BEFORE THE IDAHO DEPARTMENT OF WATER RESOURCES

)	Docket No. AA-GWMA-2016-001
)	
IN THE MATTER DESIGNATING THE)	FREMONT MADISON
EASTERN SNAKE PLAIN AQUIFER GROUND)	IRRIGATION DISTRICT,
WATER MANAGEMENT AREA)	MADISON GROUND WATER
)	DISTRICT AND IDAHO
)	IRRIGATION DISTRICT'S
)	RESPONSE TO IDWR'S
)	RESPONSE TO EXPERT
)	REPORTS
)	
)	
)	
)	
)	
)

Date: January 18, 2020
To: Jerry Rigby, Hyrum Erickson
From: Bryce A. Contor
Re: Reply to IDWR Response to
Expert Report Regarding GWMA

Figure R-1. Water Surface Elevation vs. Projected Surface Consistent with Plain - 2013 Data

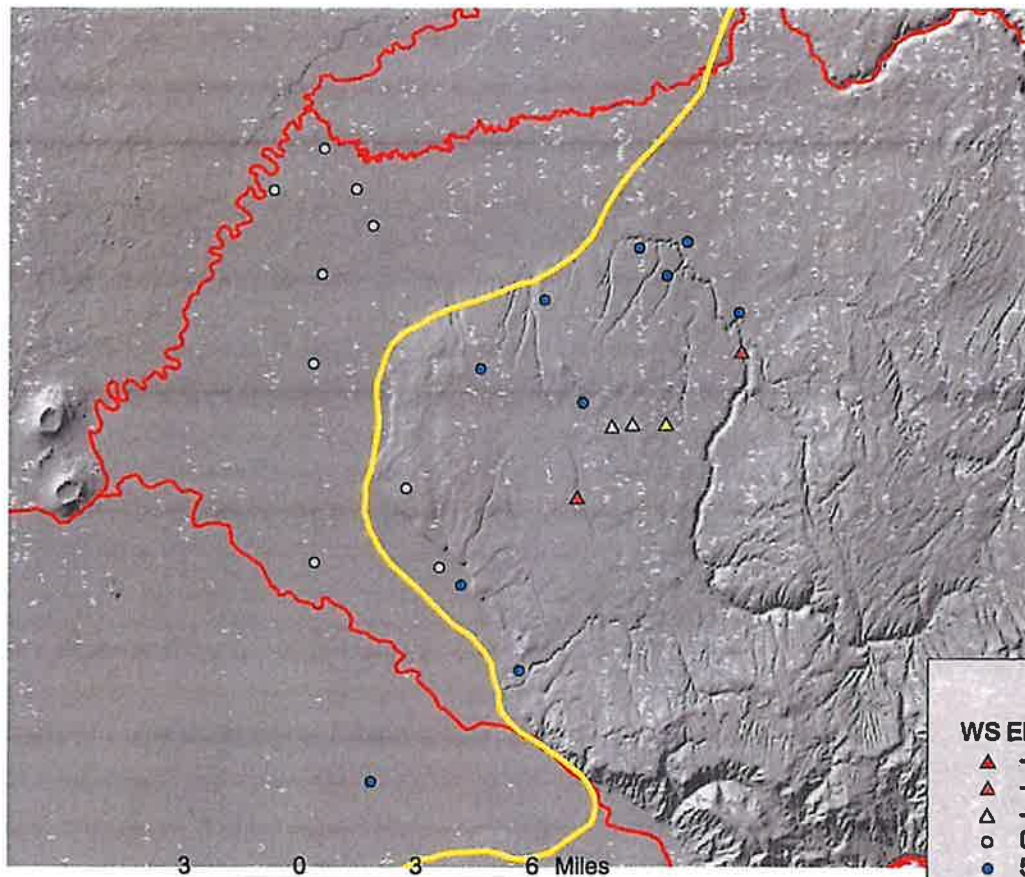
The Report presents the results as "Figure 3. Static Water Levels Relative to Projected Surface." This is perhaps mis-named, as the analysis was derived from water-surface elevations. The Report shows that static water elevations in wells on the plain tend to be relatively uniform relative to the surface of the plain itself, while on the Bench, those static water elevations are often either much deeper relative to the projected surface of the plain than in wells on the plain itself, or above the elevation of the projected surface. While the 2013 data were fewer in number than the data originally used in the Report, repeating the analysis on the same spatial extent using 2013 data produced a result qualitatively the same. Figure R-1 (attached) shows the results of the analysis with the smaller numbers of data available in the 2013 data set, with the same symbology as used in the Report. Consistent with the initial analysis, the following was found:

- The wells on the plain show water-surface elevations 10 to 83 feet below the projected surface.
- Between one-third and one-half the wells on the bench show water-surface elevations more than 83 feet below the projected surface.
- No wells on the plain show water-surface elevations above the projected surface.
- More than one-third of the wells on the Bench show water-surface elevations above the projected surface.
- Because the projected surface rises to the east, the water-surface elevations in those wells are even higher relative to the actual plain itself, than relative to the projected surface.

The 2013 data did not contradict the prior analysis that had been done using IDWR well-log data. Not all the 2013 data could be linked back to well-completion data, but a review of selected data suggests that for the most part, wells with water levels far above the projected surface are wells completed in
